Subject: September 19-20, 2018 Compliance Evaluation Inspection Report

**CWA COMPLIANCE EVALUATION INSPECTION REPORT
U.S. ENVIRONMENTAL PROTECTION AGENCY, REGION 5**

Purpose: Compliance Evaluation Inspection

Facility: FOIA Ex 6 Enterprises, LLC

Figure 2: Aerial photograph of Enterprises, LLC Longfellow Farm with Field Points.

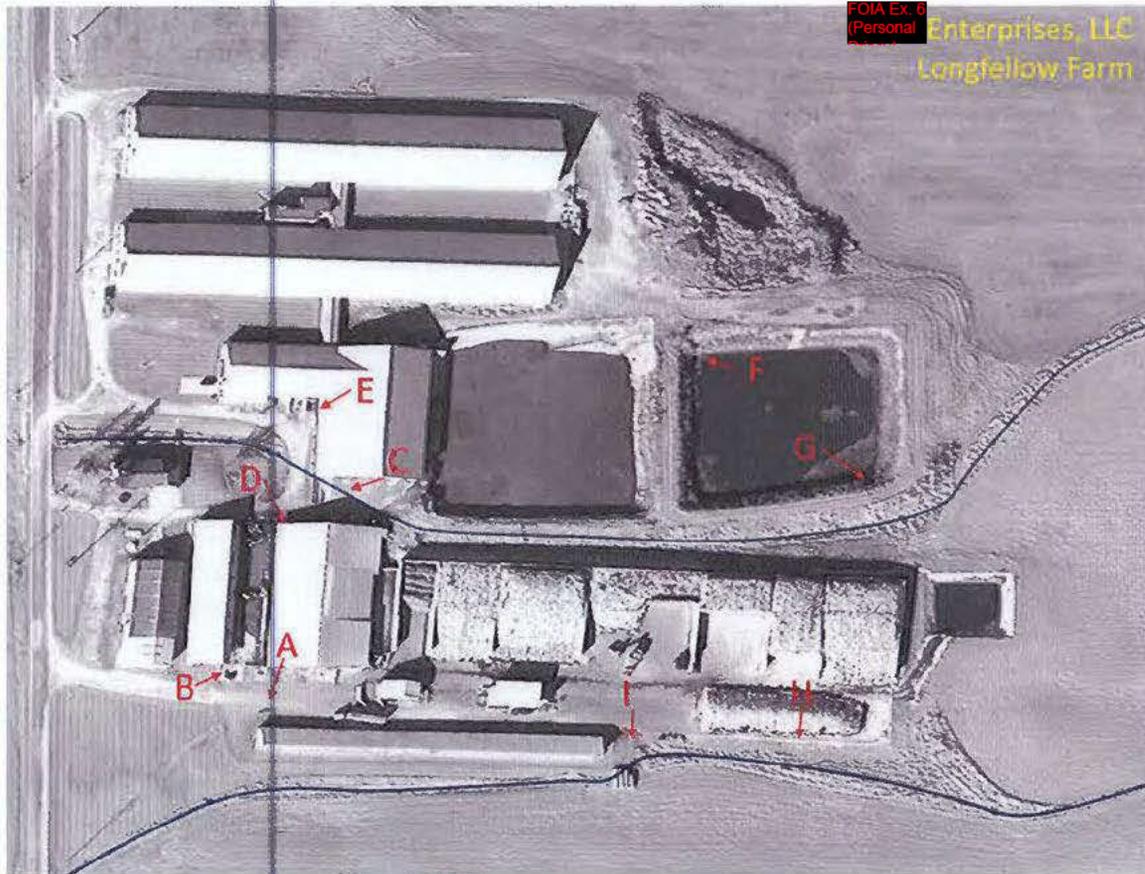
At Field Point F in Figure 2, I observed tire marks extending down the sideslope of the berm at the northwest corner of the WSP #2 (Attachment 2: RIMG0452-RIMG0453). At Field Point G in Figure 2, I observed the concrete outfall was being undercut at the southeast corner of WSP 2 by erosion of the berm (Attachment 2: RIMG0454-RIMG0455). We walked back to the south end of the site. At Field Point H in Figure 2, I observed that a portion of the concrete feed storage area was sloped such that wastewater was flowing off the southern end into a grassed area (Attachment 2:

RIMG0457). I observed that the wastewater had killed vegetation at the point where it flowed off the concrete and dead vegetation was observed approximately 10 feet into the grassed area (Attachment 2: RIMG0458-RIMG0459). This area ultimately drains the the tributary that is adjacent to the south end end of the site. At Field Point I in Figure 2, I observed feed solids on the ground in the south end of the feed storage area that could drain southeast into a grassed area (Attachment 2: RIMG0460-RIMG0461). I observed feed solids along the southern end of the barn on the south end of the site in areas that could drain to the tributary (Attachment 2: RIMG0462).

Figure 3: Aerial photograph of FOIA Ex. 6 Enterprises, LLC Main Facility with Field Points.

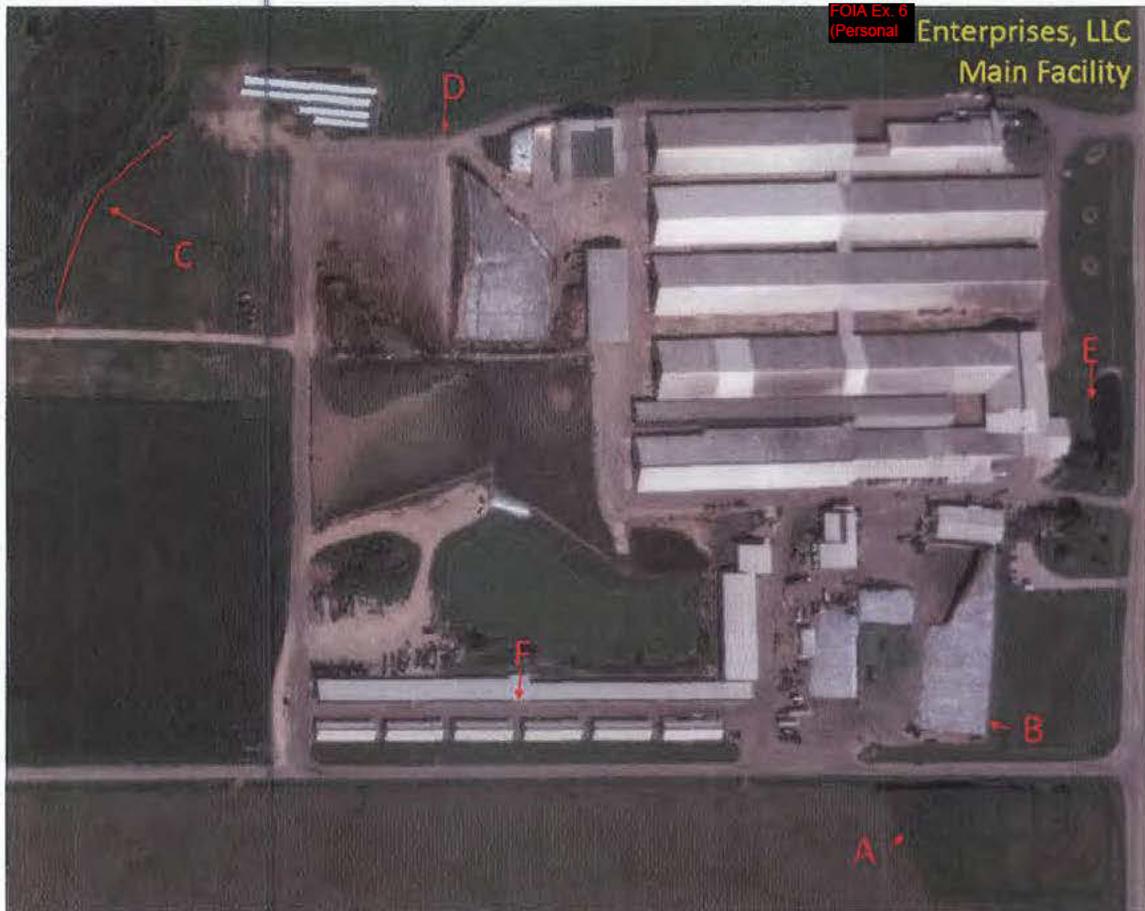
We continued west along the south end of the Main Facility. At Field Point B in Figure 3, I observed some dead vegetation on the southeast end of the bunkers likely due to bunkers releasing leachate (Attachment 2: RIMG0470). We walked to the east end of the calf and heifer barns and then continued north. The farm lane between the calf and heifer barns drains from west to east into a stormwater inlet that outlets to the pond at the center of the facility (Attachment 2: RIMG0471). Stormwater piping was observed northwest of the feed storage area (Attachment 2: RIMG0472). I observed a small amount of sheen on the water surface that drained to the stormwater inlet (Attachment 2: RIMG0473).

We walked east along the north end of the facility. At Field Point D in Figure 3, along the north end of the feed storage area, I observed feed solids blown into the field (Attachment 2: RIMG0490). I observed water with a brownish color in the field north of the feed storage area (Attachment 2: RIMG0491). Further east, I observed that the fans blowing out of Freestall Barn #5, northernmost barn, were depositing solids on the asphalt which drains to a storm water inlet (Attachment 2: RIMG0493). A stormwater inlet was located between barns (Attachment 2: RIMG0494). At Field Point E in Figure 3, I observed water that was light brown in color discharging from the storm water pipe into the pond on the east end of the facility (Attachment 2: RIMG0495). The final disposition of the stormwater pond was unknown (Attachment 2: RIMG0496). At the closing conference, Ex. 6 (Personal Privacy) stated that if the stormwater pond filled enough that it could flow south along the road ditch.

from west to east (Attachment 2: RIMG0499). At Field Point F in Figure 3, I observed track out of manure at the heifer barns which would flow with stormwater to the east (Attachment 2: RIMG0500). I observed that the stormwater flows east to a stormwater inlet and outlets into the center storm water pond (Attachment 2: RIMG0500-RIMG0501). I observed the stormwater outlets at the southwest corner of the stormwater pond (Attachment 2: RIMG0502). The final disposition of the pond is unknown. There were no managed outfalls. The inspection walkthrough concluded at 11:00 a.m.
